City of Mississauga Department Comments

Date Finalized: 2023-11-22 File(s): A441.23

Property Address: 881 Edistel Crescent

Appendix 1 – Transportation and Works Comments

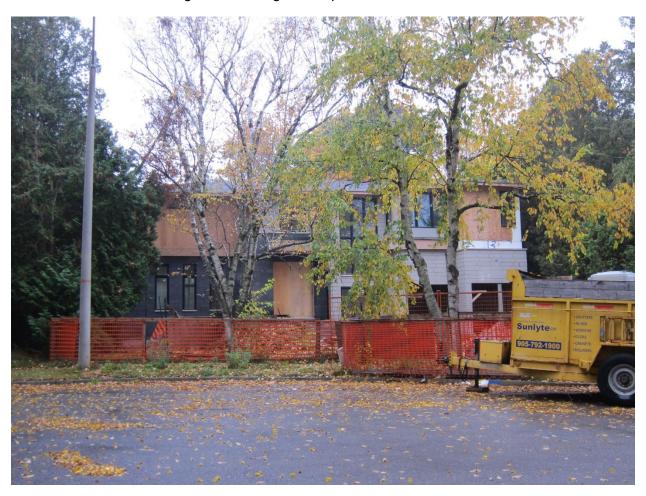
We are noting for Committee's information that any Transportation and Works Department concerns/requirements for the proposed dwelling were addressed by our Development Construction Section through the Building Permit process, File BP 9ALT-21/8442.
